5 March 2020

TECHNICAL REVIEW OF ASSESSMENT OF EFFECTS ON THE ENVIRONMENT FROM BRICK MANUFACTURING ON A PROPOSED PLAN CHANGE AREA IN DARFIELD

Figure 1 Proposed Plan Change Site in Red

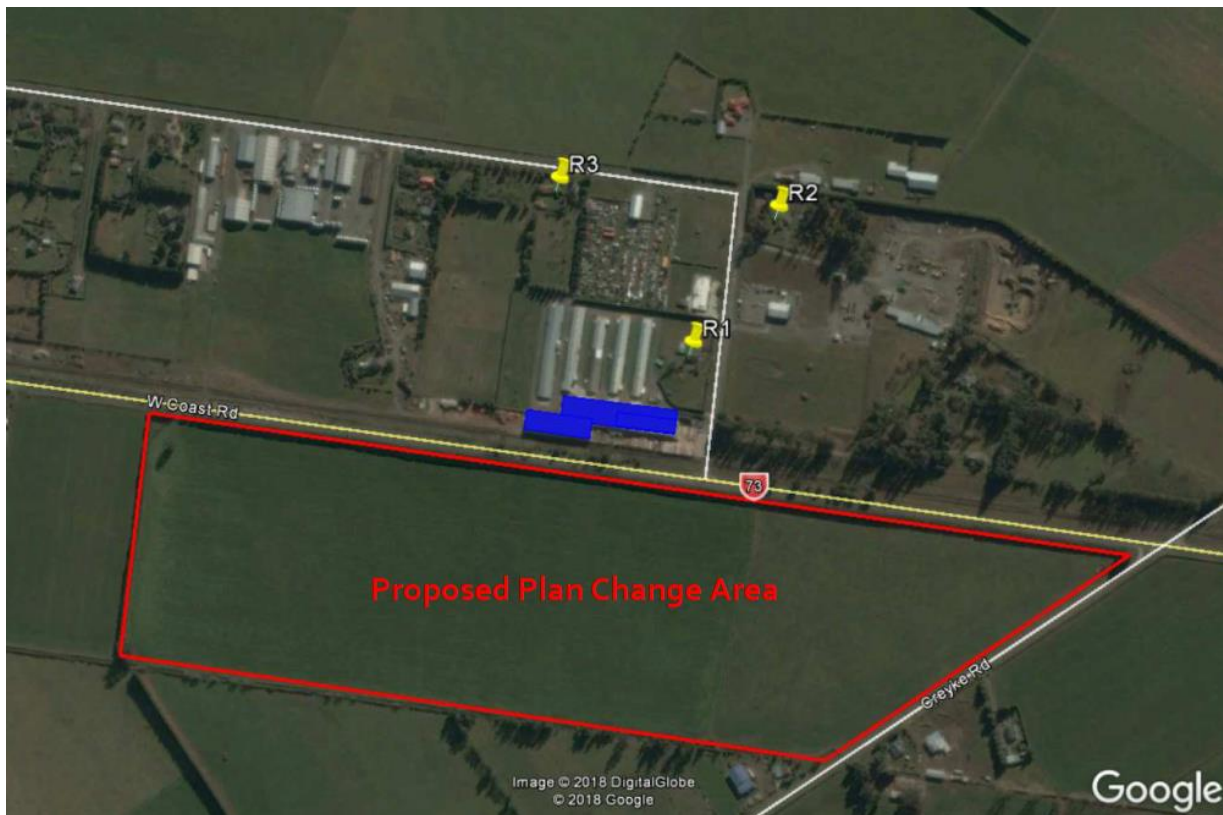
An aerial image of the proposed plan change area (outlined in red), the brick manufacturing site (in blue), and nearby residences is shown as Figure 1 below. The proposed plan change area will consist of Business 2 Zone across the northern length of the parcel, which will serve as a buffer to the residential zone at the southern end of the parcel.

Figure 2 Modelled meteorological dataset for use with AERMOD, 2015-2017

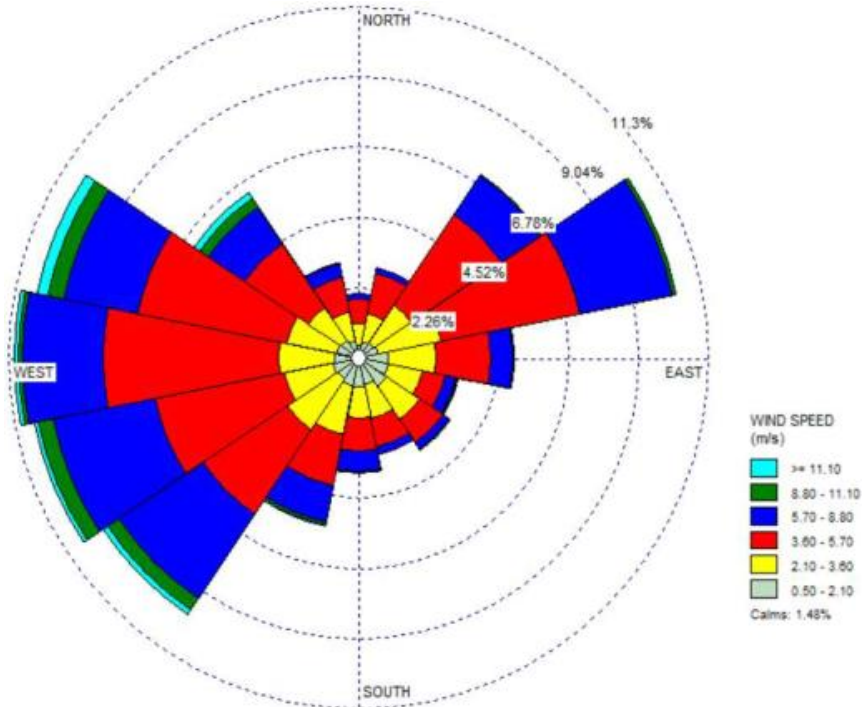
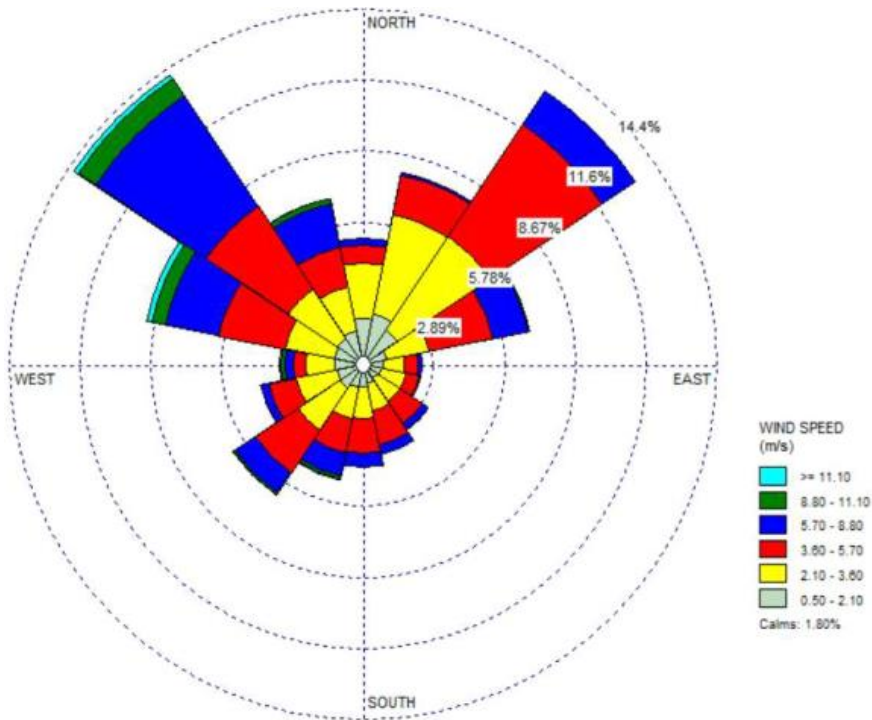
A wind rose of the modelling dataset is provided as Figure 2 below. For comparison, a wind rose of actual meteorological data collected at the Darfield EWS meteorological station approximately 1.5 kilometres to the east-southeast is provided as Figure 3. The modelled meteorological data differs from the measured winds in that the strongest winds in the modelling data occur from the west, whereas they occur from the northwest and northeast in the observed data.

The higher frequency of northerly wind directions measured in Darfield compared to what was modelled could potentially result in an underprediction of concentrations within the proposed plan change area to the south of the brick manufacturing site. However, given that the assessment used three years of meteorological data to model the discharges, and the discharges were modelled on a continuous 24-hour basis over this period, it is probable that worst-case meteorological conditions for dispersion from the northerly directions would be observed and accounted for in the modelling.
